U.S. NUCLEAR REGULATORY COMMISSION  
**STANDARD REVIEW PLAN**  
OFFICE OF NUCLEAR REACTOR REGULATION

6.2.1.5 MINIMUM CONTAINMENT PRESSURE ANALYSIS FOR EMERGENCY CORE COOLING SYSTEM PERFORMANCE CAPABILITY STUDIES

DRAFT Rev. 3 - April 1996

**SRP Draft Section 6.2.1.5**  
Attachment A - Proposed Changes in Order of Occurrence

Figure 1  
Area of Steel Heat Sinks Inside Containment

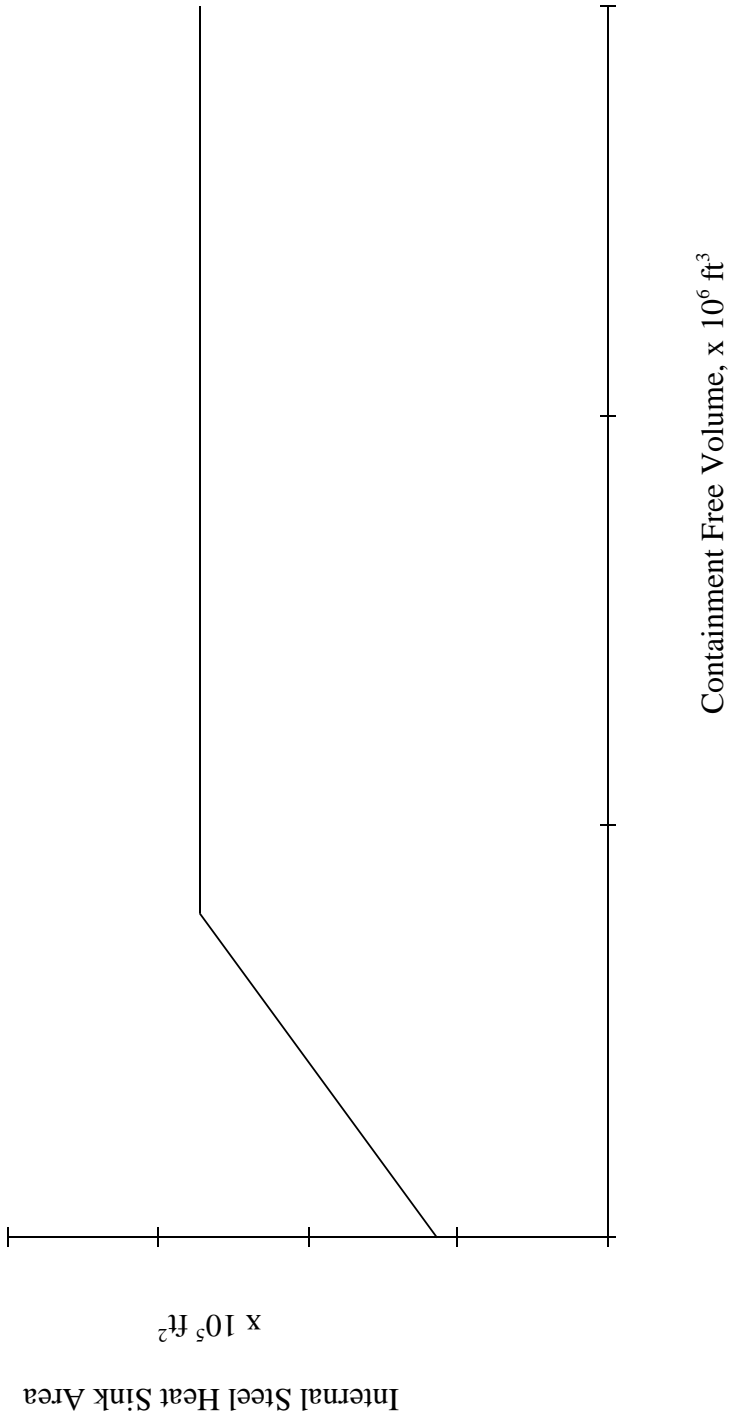
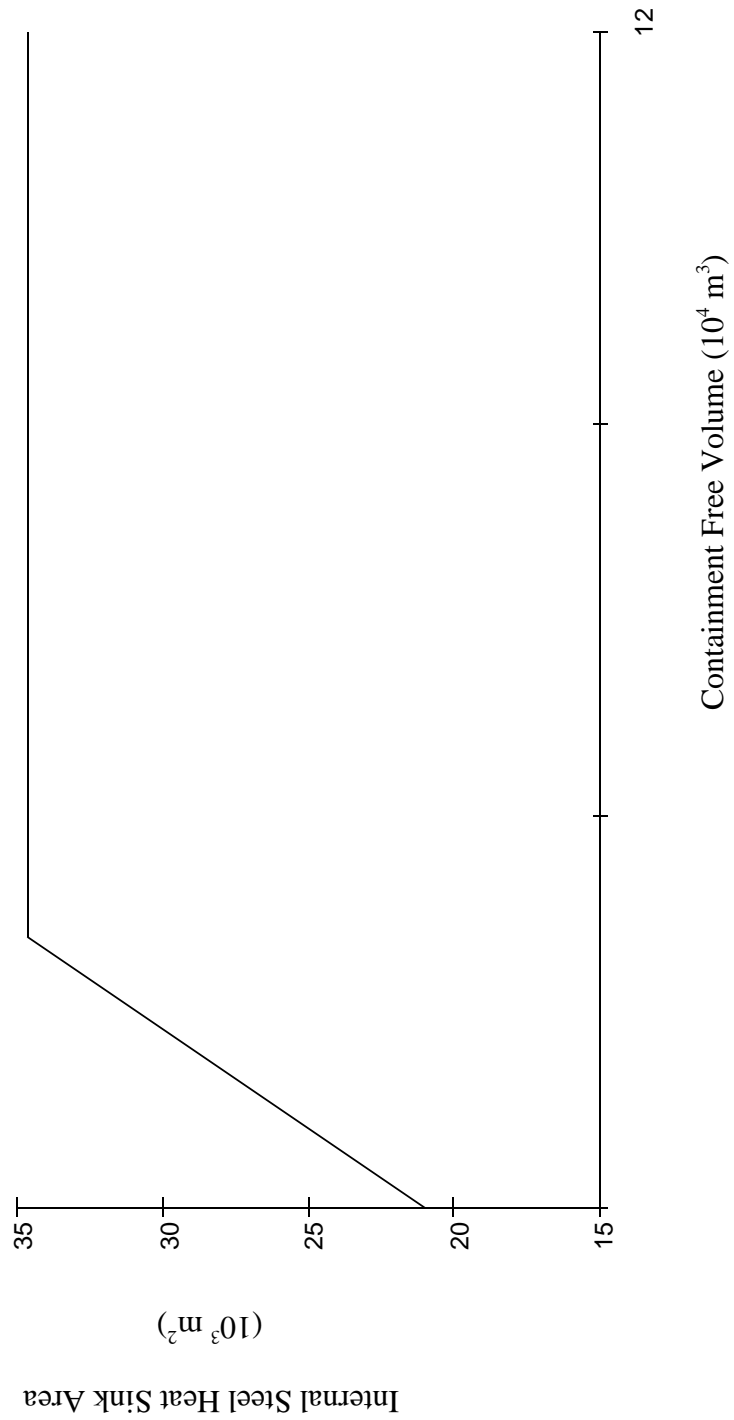
This figure uses English units, and will therefore be replaced by the figure on page 14.<sup>42</sup>

This figure supercedes the figure on page 13.

45.	SRP-UDP format item, Metrication policy implementation	Units of ft <sup>2</sup> vs ft <sup>3</sup> for existing Figure 1 were converted to units of m <sup>2</sup> vs m <sup>3</sup> using the guidance of Federal Standard 376B. See enclosed conversion documentation. Also, the unit labels were changed to a (10 <sup>3</sup> m <sup>2</sup> ) and (10 <sup>4</sup> m <sup>3</sup> ) format for clarity.
